MAINE TURNPIKE AUTHORITY

ADDENDUM NO. 2

CONTRACT 2019.15

GRAY TRAVEL PLAZA
FUEL SYSTEM REPLACEMENT
MILE 58.8 NB

CANOPY DRAINAGE DETAIL
N.T.S.

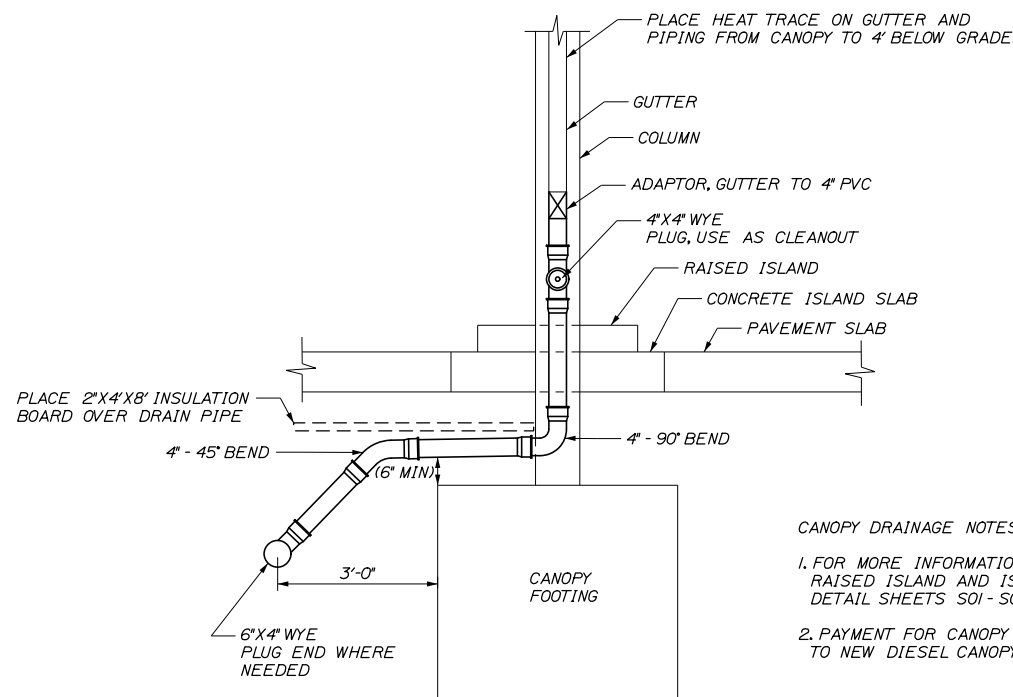
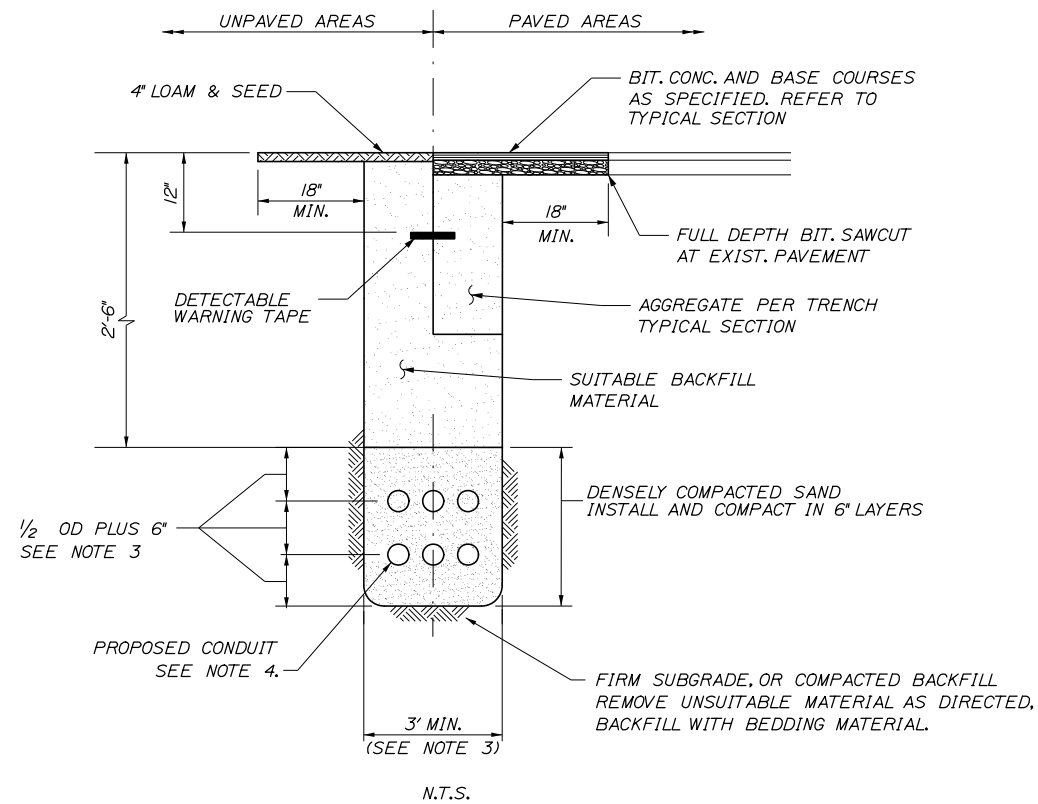
No.	Revision	By	Date
1	REMOVED DIVERSION STRUCTURE	DAM	7/19

STANDARD PIPE/CONDUIT TRENCH DETAIL

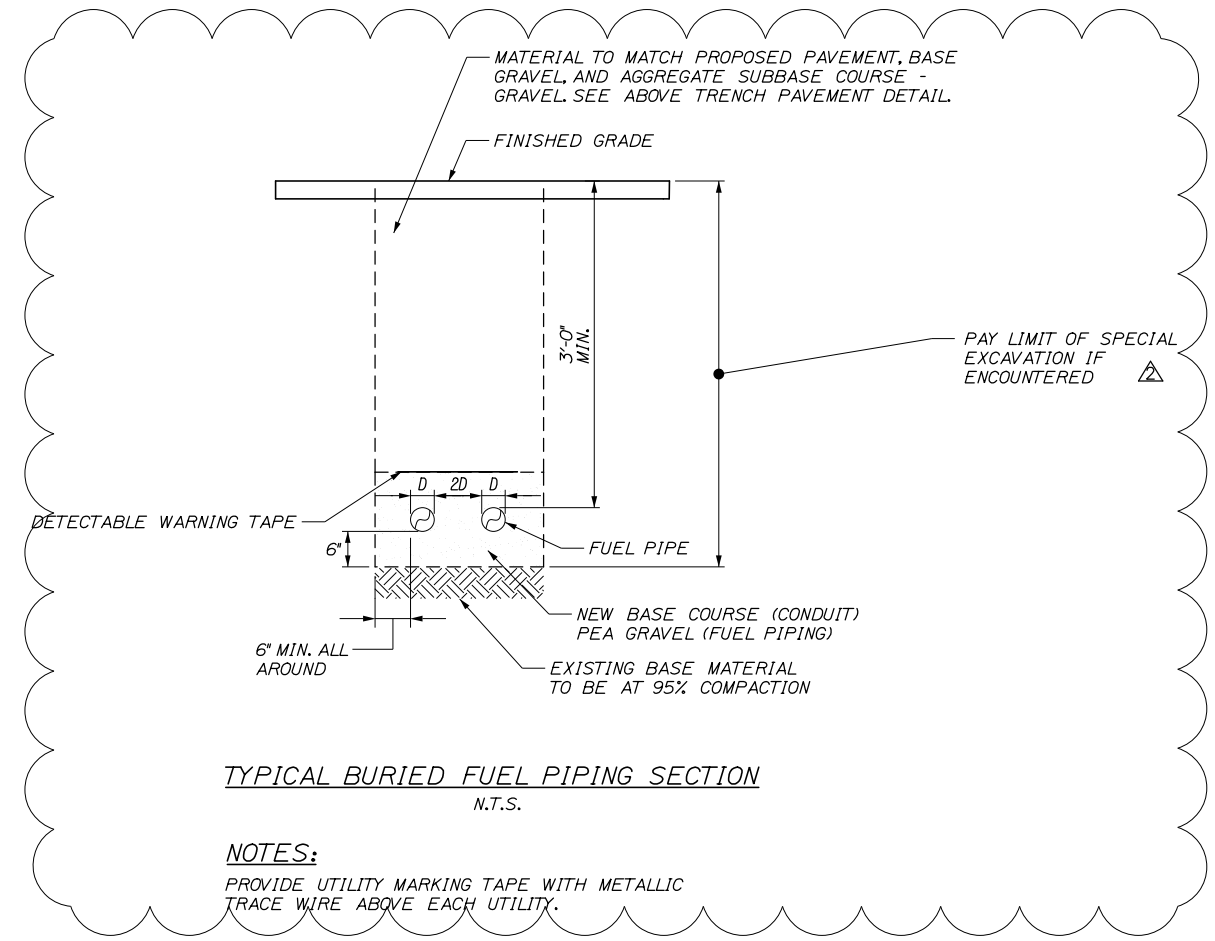
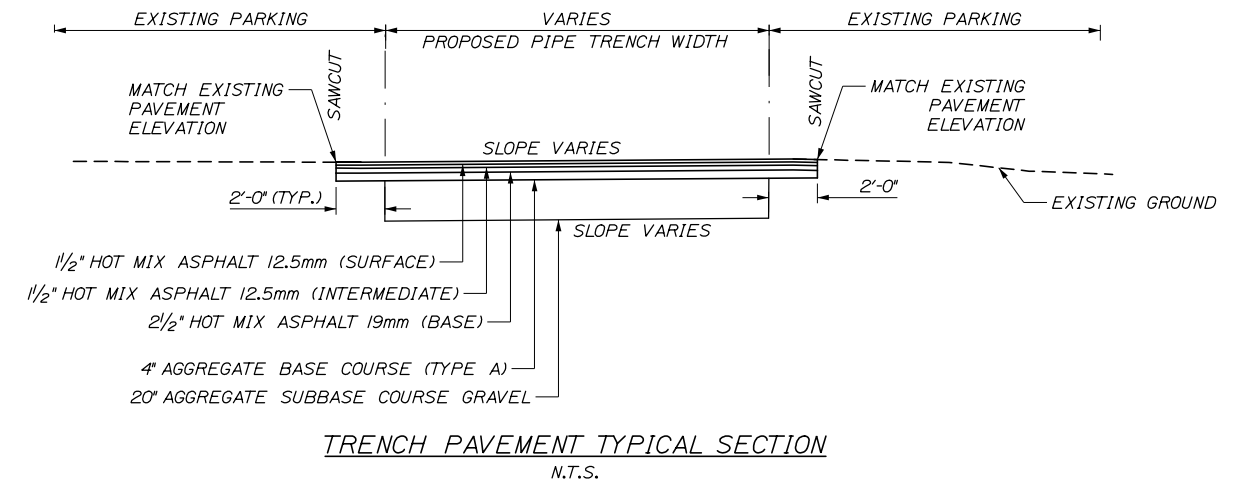
- 2) Typical buried fuel piping detail, what is the pay limit of special excavation, the dashed line ends at the top of the conduit fill section, I suspect the limits goes to the bottom of the trench?

No.	Revision	By	Date
1	CLARIFIED PAY LIMITS	DAM	7/19

Response: The detail shall be revised to clarify pay limits.

GRAY SERVICE PLAZA
 FUEL SYSTEM REPLACEMENT
 MAINTENANCE OF TRAFFIC
 PHASE 1

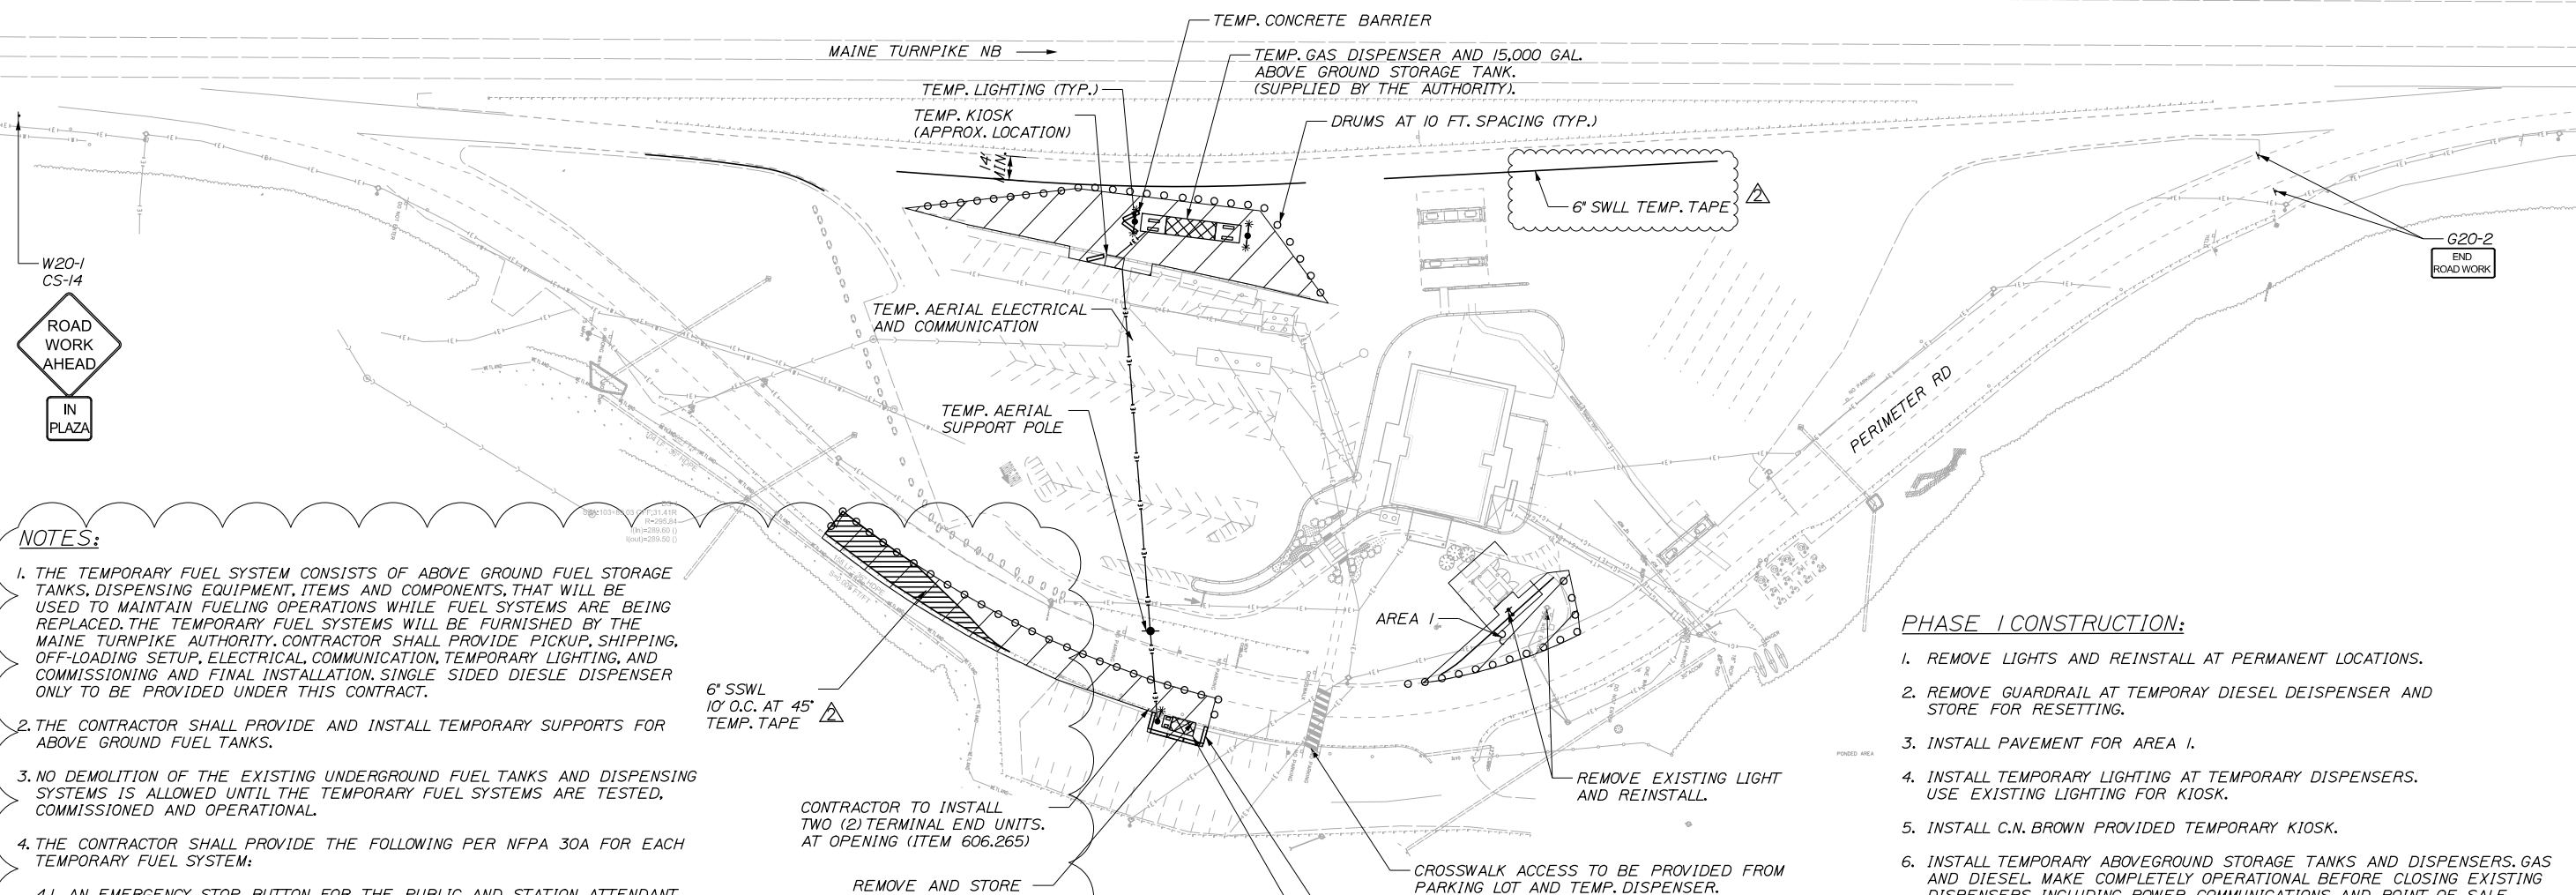
- 3) Can tape be used to delineate the no parking zone prior to the fuel station for diesel?

No.	Revision	By	Date
1	REVISED NOTES & TEMP. PAINT	DAM	7/19

Response: Yes, temporary striping shall be revised to tape.

GRAY SERVICE PLAZA
FUEL SYSTEM REPLACEMENT
MAINTENANCE OF TRAFFIC
PHASE 2

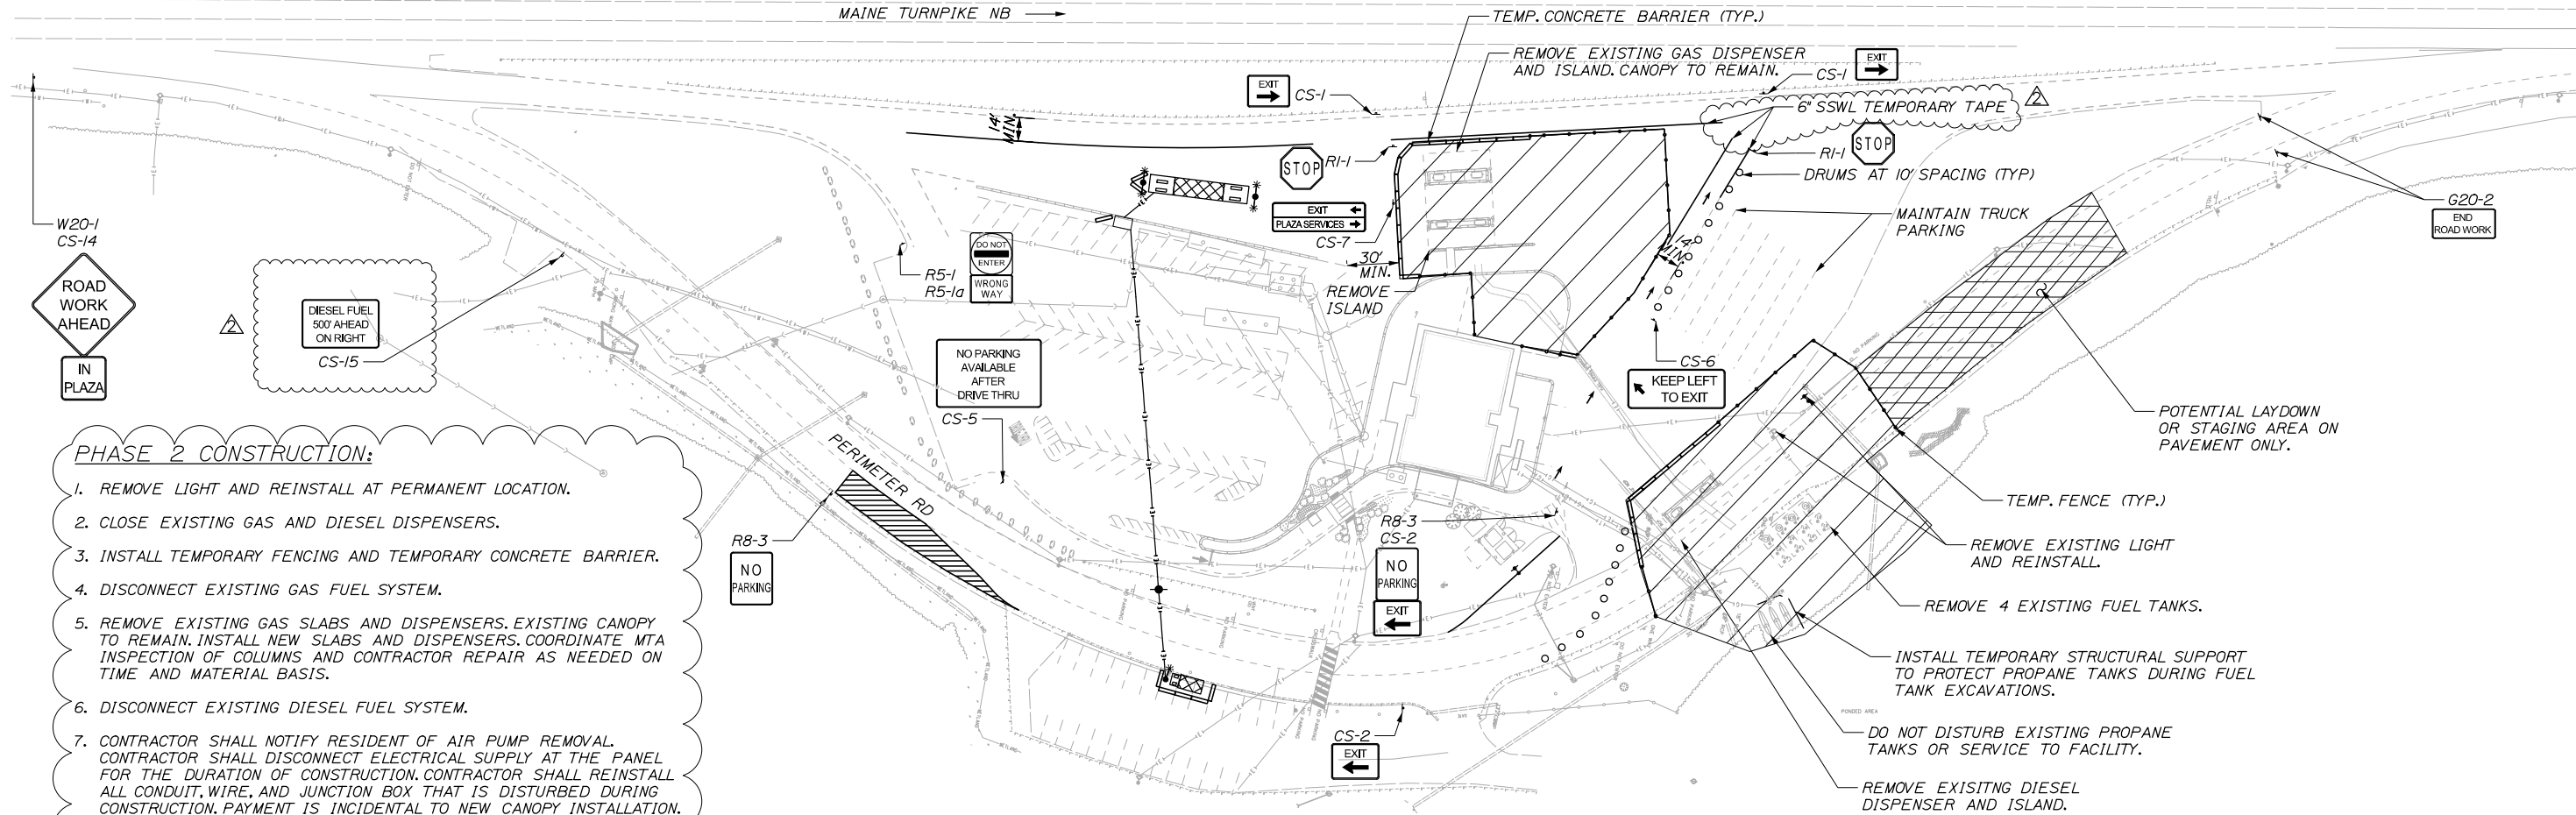
- 8) Where does the MTA require any unused granite curb be stockpiled?

No.	Revision	By	Date
1	REVISED NOTES & TEMP. PAINT	DAM	7/19

Response: Unused granite curb shall become the property of the contractor. Plan notes shall be revised.

1. CONTRACTOR SHALL MAKE ACCOMMODATIONS FOR SCHEDULED SERVICE PLAZA AND FUEL STATION DELIVERIES.
2. GRANITE CURB REMOVED AND NOT REUSED SHALL BECOME THE PROPERTY OF THE CONTRACTOR
3. SEE SHEET SS-01 FOR SIGN DETAILS.
